Serial No. 10/679,820

R E M A R K S

**Amendments to the Drawings:**

Ser. No. 10/679,820  
Annotated Sheet Showing Changes

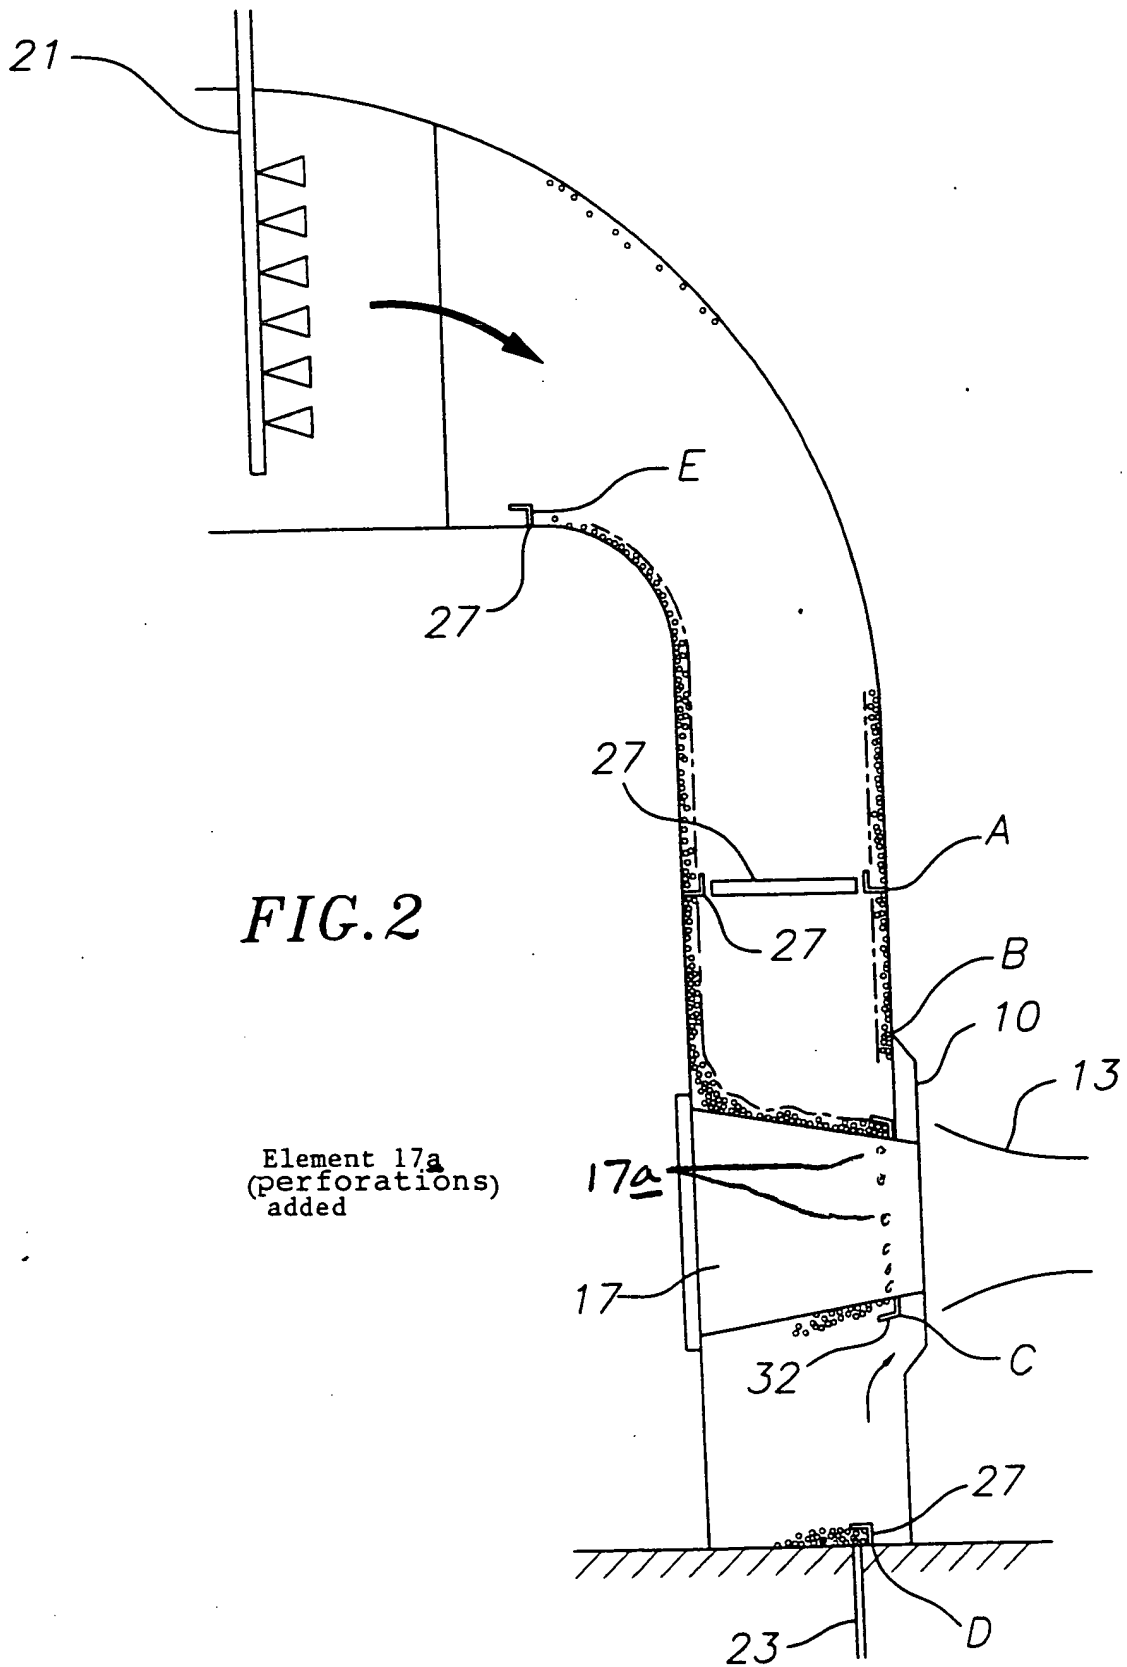
The attached sheet of drawings includes changes to Fig. 2. This sheet replaces the original sheet showing Fig. 2. In Fig. 2, previously omitted element 17a has been added.
